Architectural Review Board

Staff Report (ID # 9699)

Summary Title: 250 Sherman: Subcommittee Review of Public Safety Building

Title: 250 Sherman Avenue [17PLN-00256]: Subcommittee Review of the Previously Approved Public Safety Building That was Conditioned to Return With Project Changes for Bollard Lighting and Material Finishes, Textures and Colors. For More Information Contact the Chief Planning Official Amy French at amy.french@cityofpaloalto.org

Product data sheet

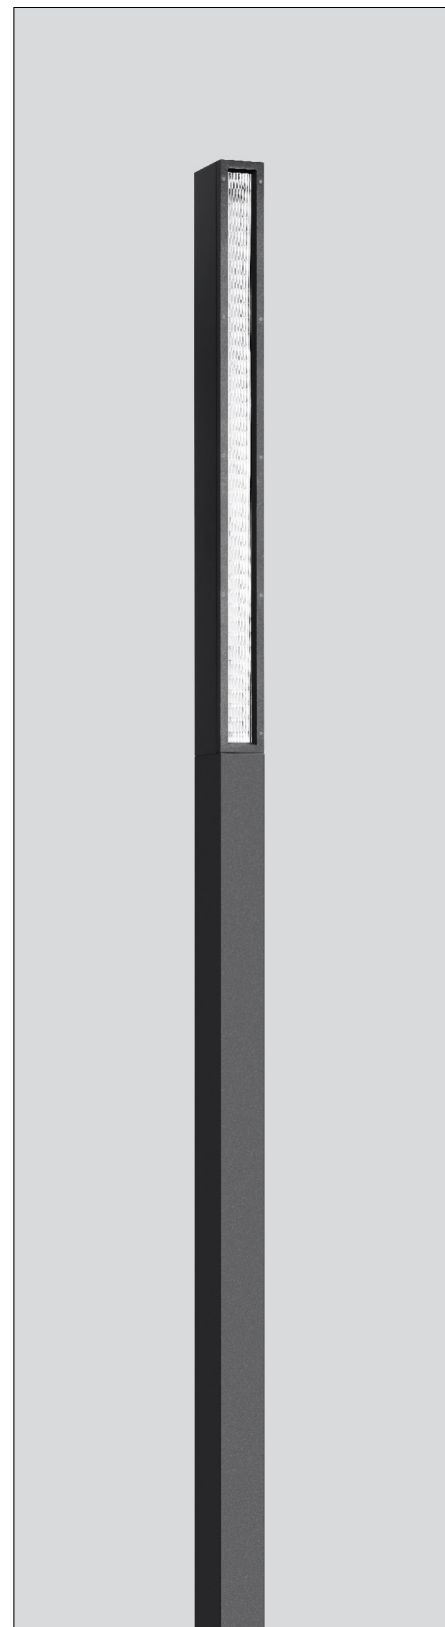
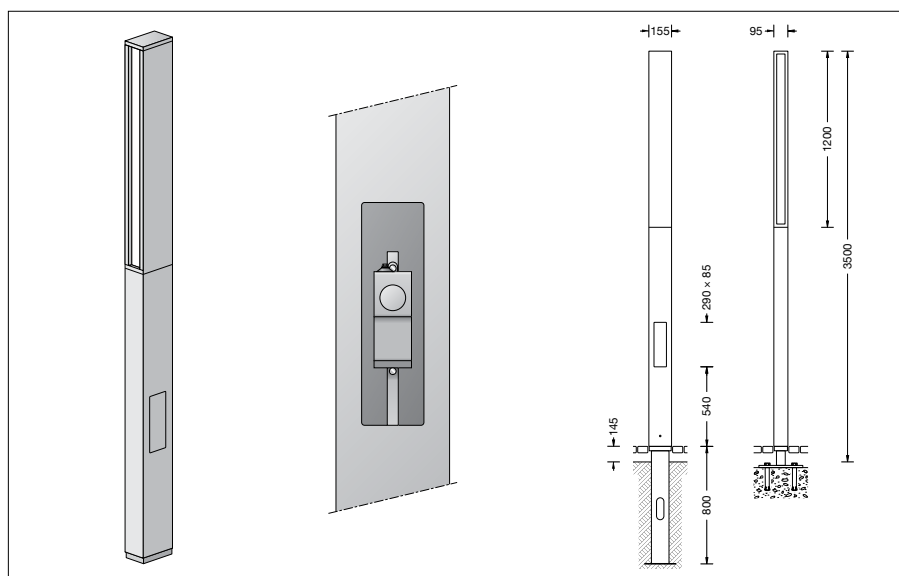
Item a. Four E-1 light fixtures (bollard lights near Birch Street) changed to less-glare fixtures.

The design team is proposing an alternate pole fixture which screens the light in two directions. The fixture is rectangular, similar in height as the fixture shown at the 9/20 meeting. An image is provided below and a cut sheet describing the fixture is provided as Attachment C.
